## ADDENDUM NUMBER THREE 07/10/2015

PROJECT: ROY WARNER PARK-PHASE 1 DEVELOPMENT

FROM: Johnson, Laschober & Associates, P.C.  
1296 Broad Street  
Augusta, GA 30901  
(706) 724-5756

**1**  
**RISER DIAGRAM**  
 E-300  
 NO SCALE

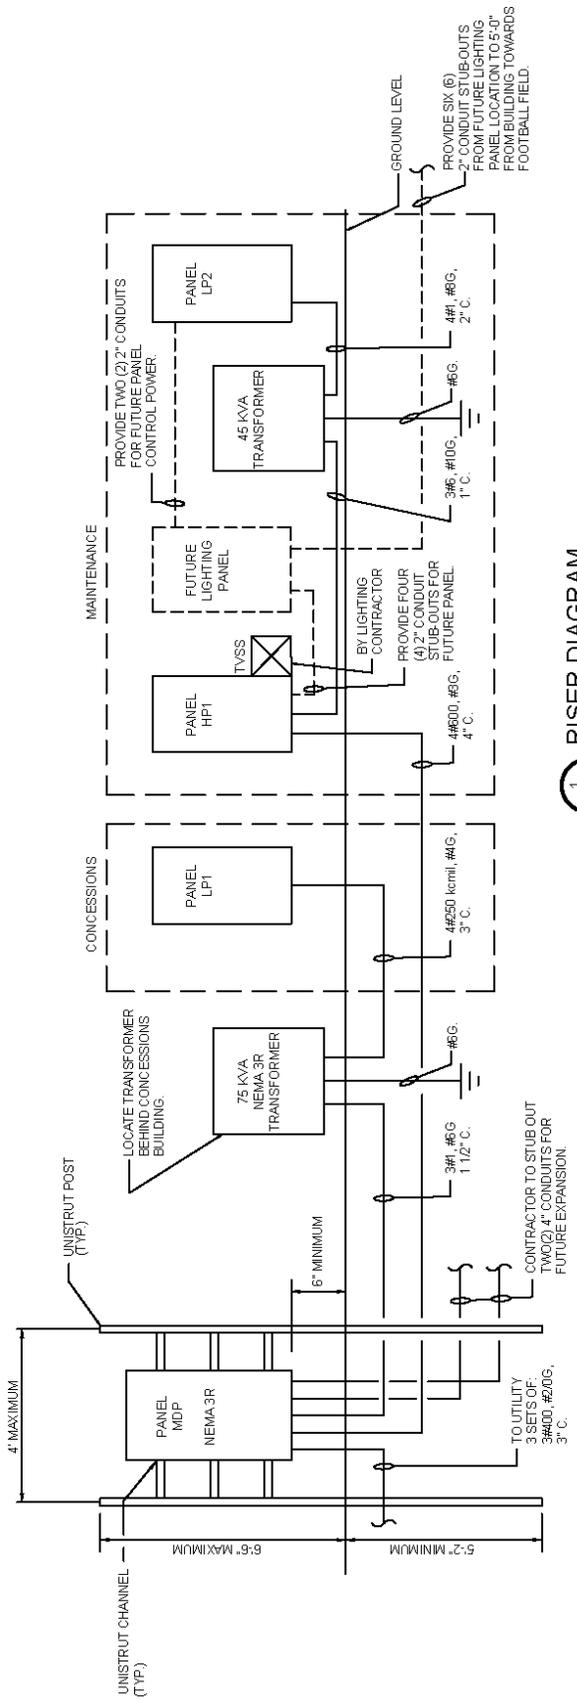
Question: On Drawing E202, The Detail about Musco's Light stated the owner will provide material?

Question: On Drawing E-300, The panel detail, for the controls who is responsible for this installation?

Response: Delete all references to Musco field lights, field lighting poles, wiring, and lighting accessories. See attached Riser Diagram for further clarification. As indicated on attached Riser Diagram provide empty conduit and adequate wall space for future panels.

Response: Delete all references to Musco field lights, field lighting poles, wiring, and lighting accessories. See attached Riser Diagram for further clarification. As indicated on attached Riser Diagram provide empty conduit and adequate wall space for future panels.
